SERVICE BULLETIN

28-Jul-2026

KALLITHEA

Replacement of the Turbocharger–
Intercooler Flexible Hose and Updated
Installation Procedure

Fig. 1

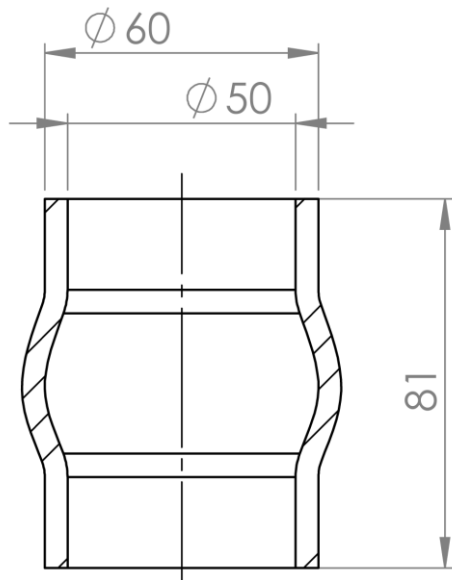
- flexible silicone coupling with one hump x1 (Fig. 1)
- hose clamp (ABA Original S20 Aluzink x2 (Fig. 2)

Fig. 3

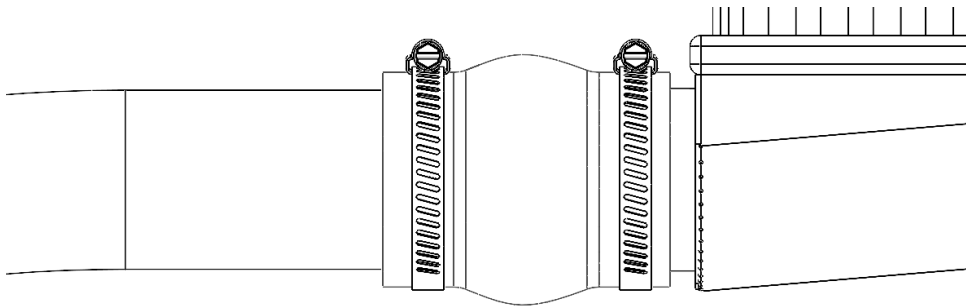
This Service Bulletin introduces an updated flexible hose assembly and installation procedure for the connection between the turbocharger outlet and the intercooler.

- Fig. 3 – Updated hose configuration
- Fig. 4 – Correct clamp position
- Fig. 5 – Incorrect clamp position

Fig. 4

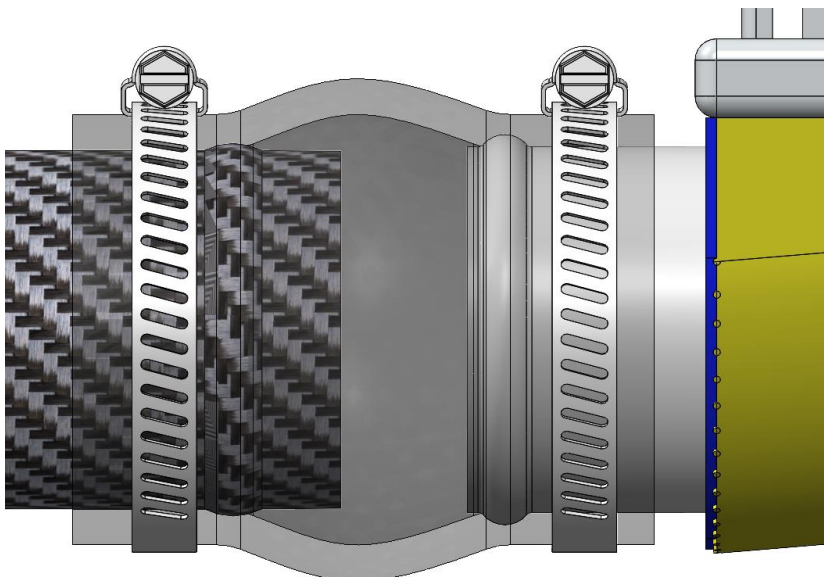
- 1) Install the updated flexible hose.
- 2) Install new hose clamps.
- 3) Ensure the hose is fully seated on both connections.
- 4) Position the hose clamps aft of the hump on the carbon fiber pipe
- 5) Tighten clamps to the specified torque.

Torque: 8 Nm
